NUCLEAR REGULATORY COMMISSION (NRC) – BELLEFONTE NUCLEAR
PLANT (BLN) – RESPONSE TO NRC INFORMATION NEEDS RELATED TO
CULTURAL RESOURCES

**Response to NRC Information Needs
Related to
Cultural Resources (CR)**

NRC Review of the BLN Environmental Report

NRC Environmental Category: CULTURAL RESOURCES

**AERIAL PHOTOGRAPH
BELLEFONTE SITE AND PROJECT
AREA OF POTENTIAL EFFECT**

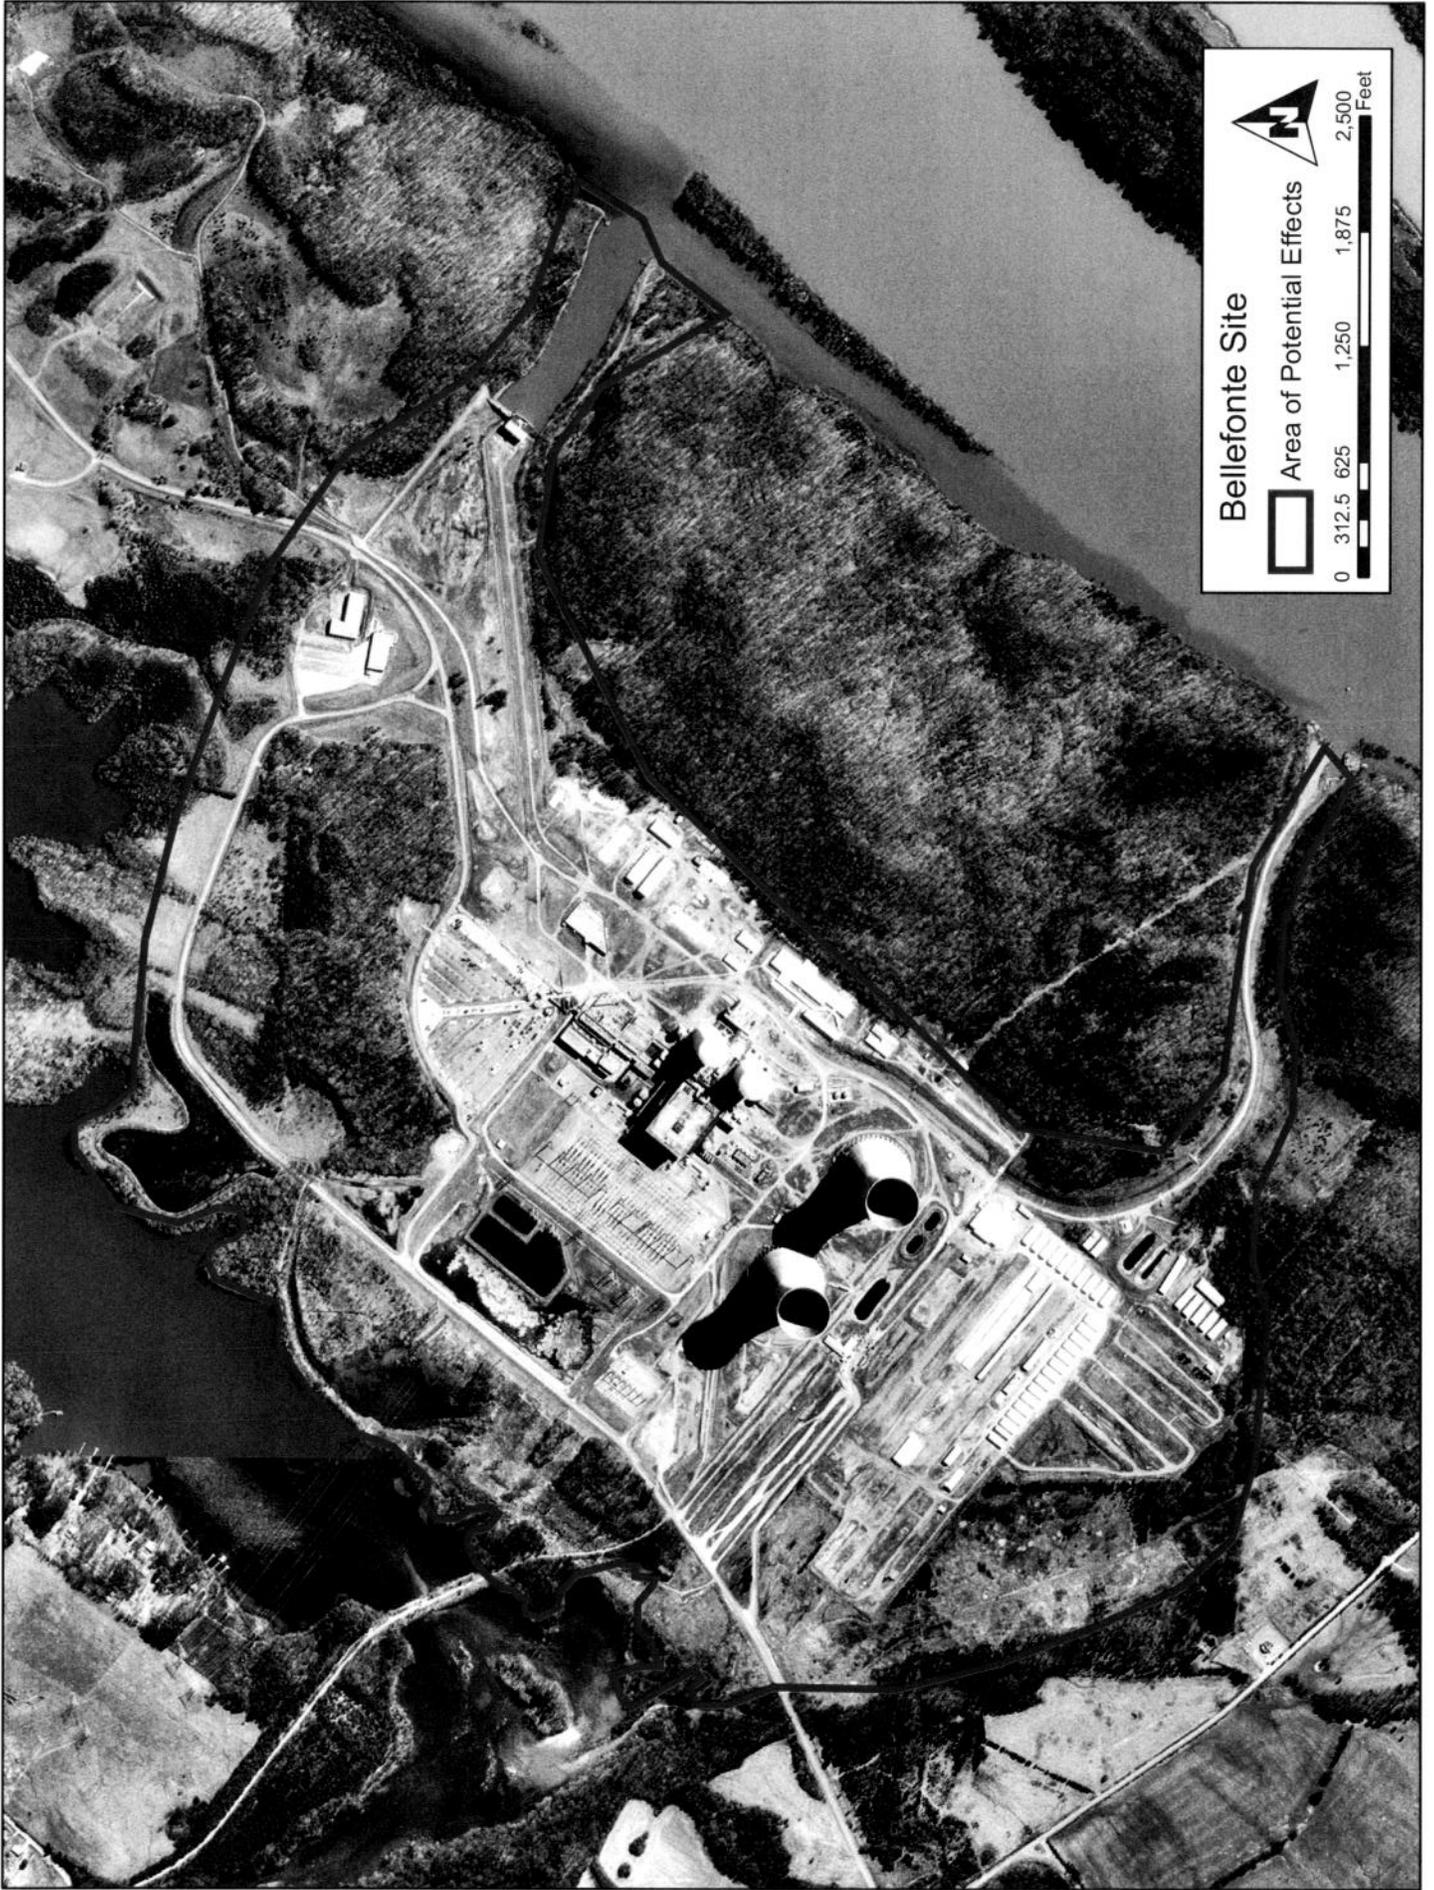
- CR-10:** Provide current aerial photographs of BLN site, if available.
- CR-15:** Describe process for determining APE.

A current aerial photograph of the BLN site, with the project area of potential effect (APE) superimposed, is provided as Attachment A to this letter.

TVA recommended a project APE consisting of approximately 606 acres of land located within the BLN site. This APE was defined so as to include the primary construction footprint, as well as laydown areas, anticipated on-site road construction, and other ground-disturbing activities that are expected to occur as a result of plant construction and operation.

Aerial Photographs
Bellefonte Site Under Construction
(1977 – 1981)

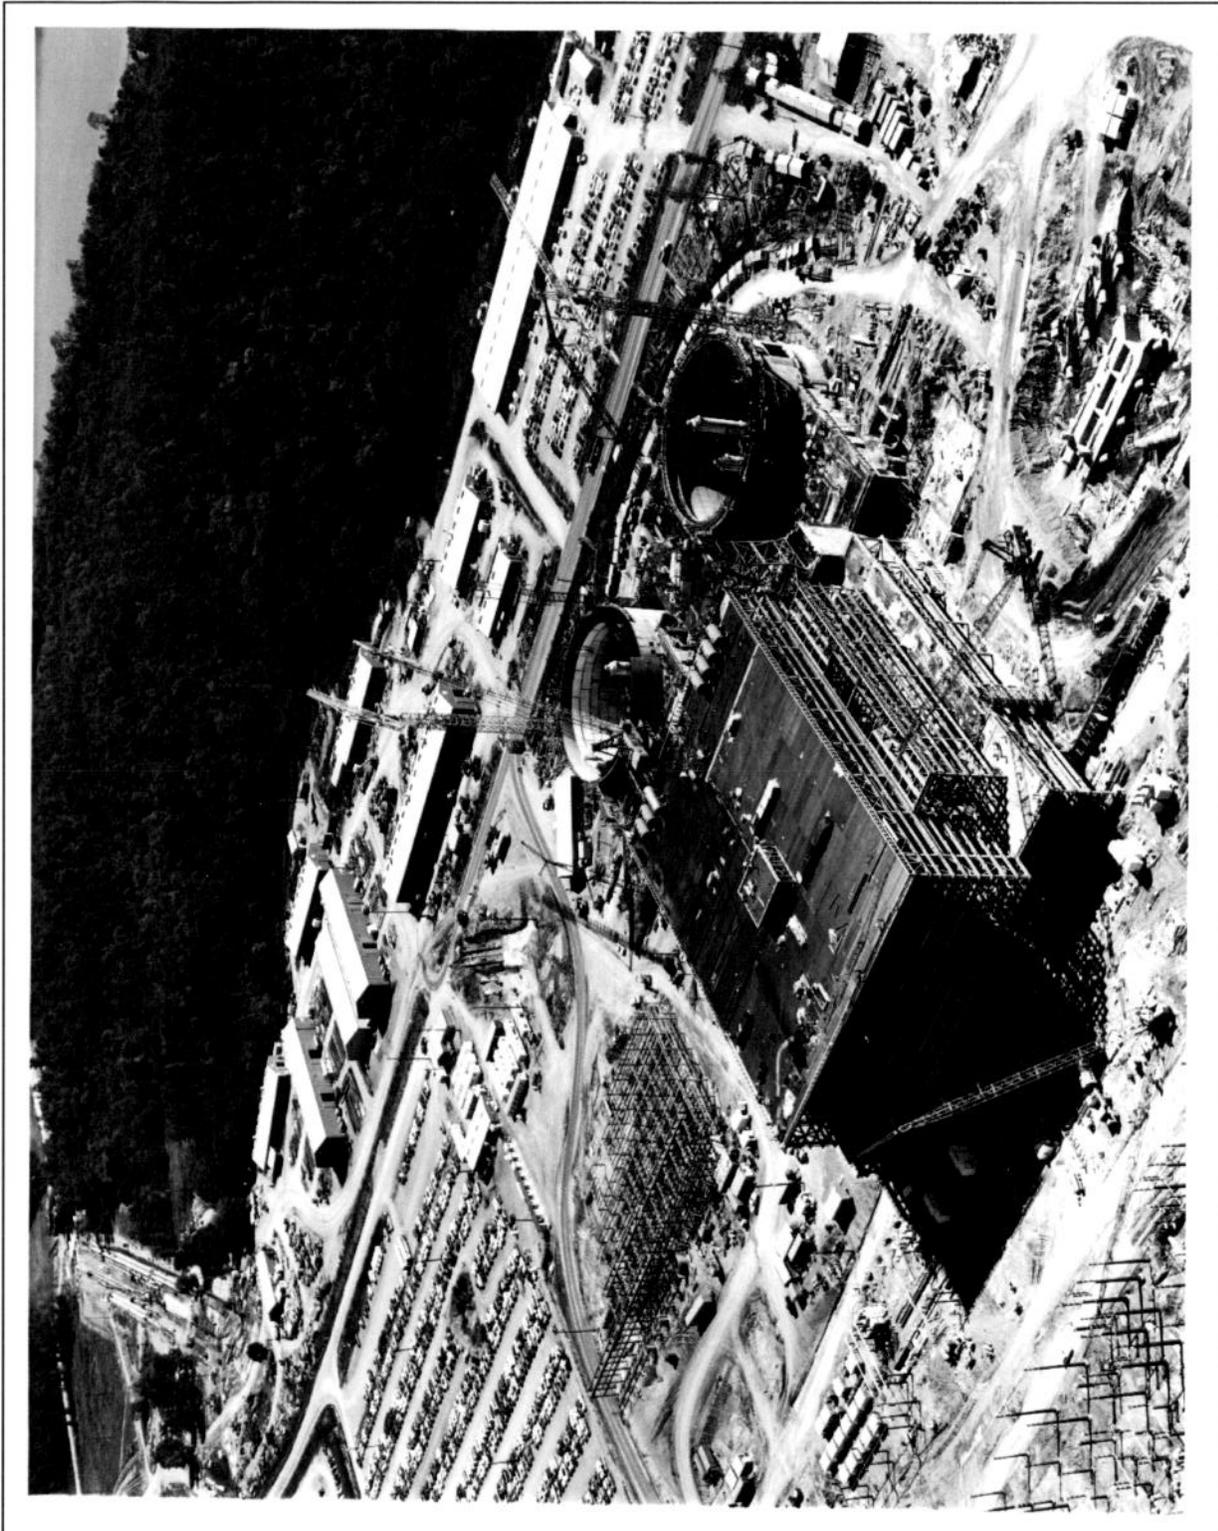
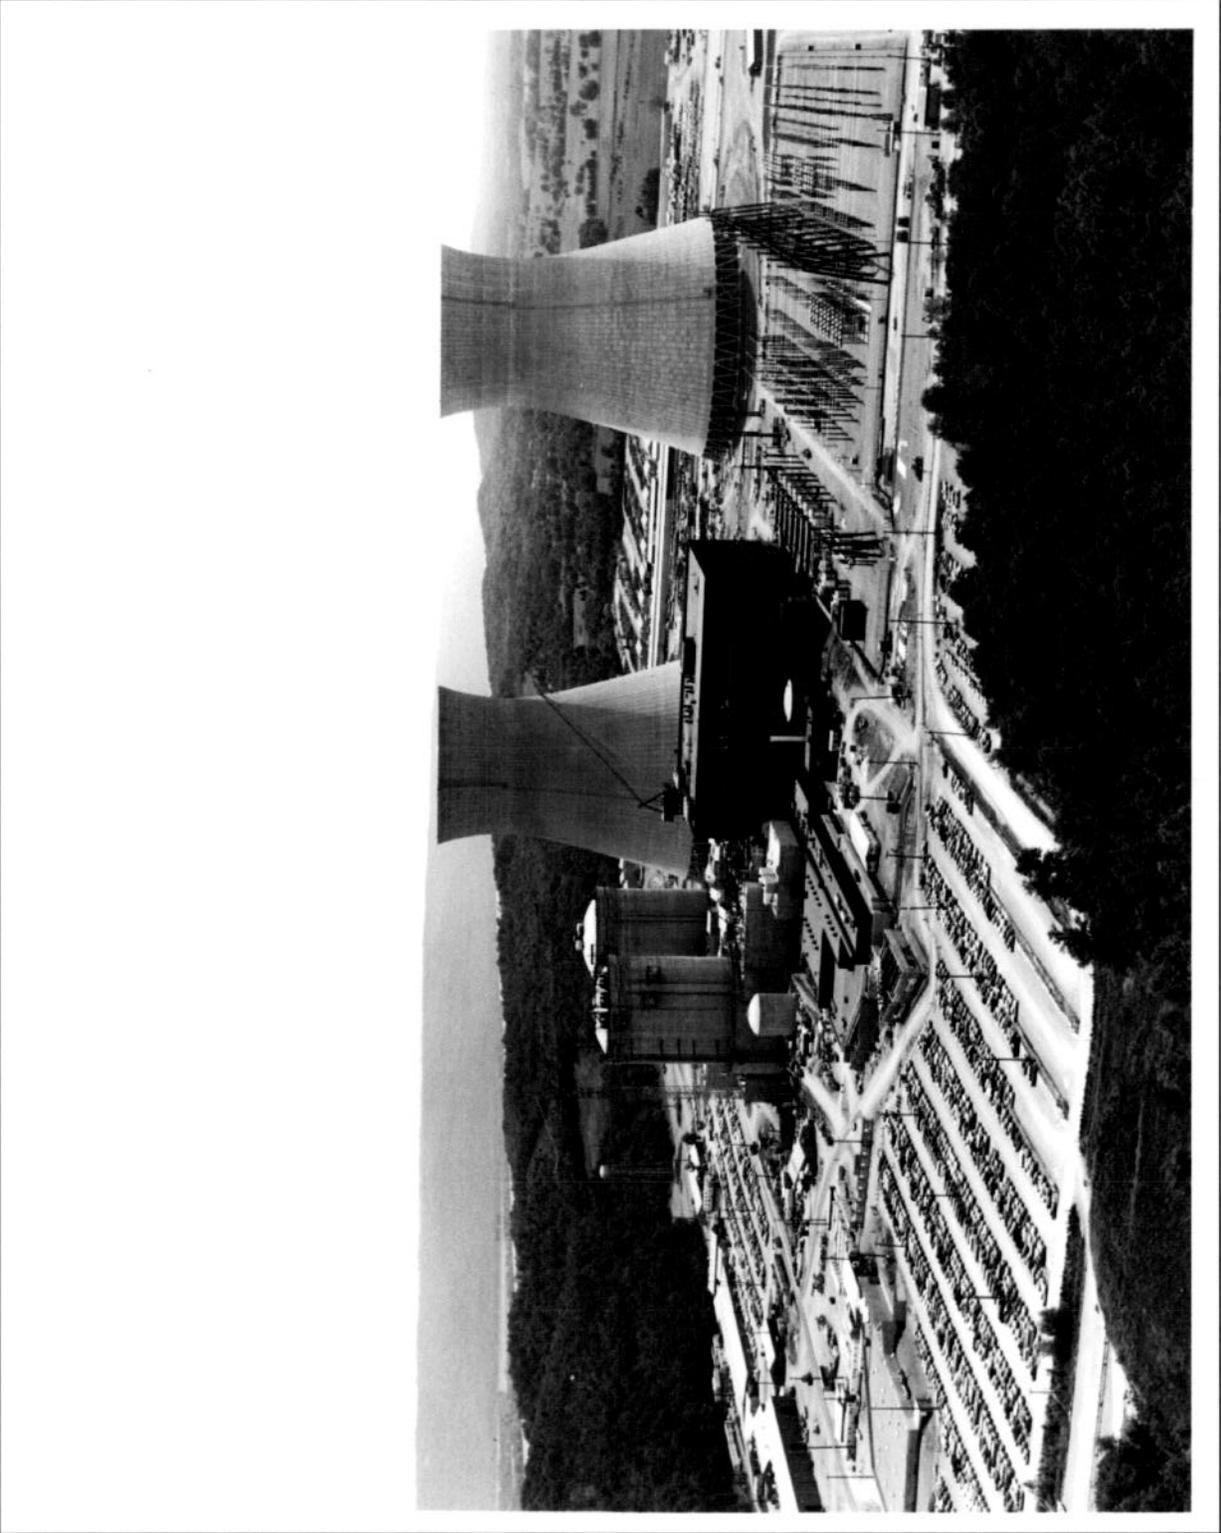
- CR-11:** Provide historic aerial photographs of BLN site showing extent of construction disturbance, if available.

Three aerial photographs showing the Bellefonte site during construction of the Bellefonte Units 1 and 2 reactors, cooling towers, and other facilities are provided as attachments to this letter. These photographs depict the extent of construction disturbance in October 1977, June 1981, and during the interim period between these two dates.
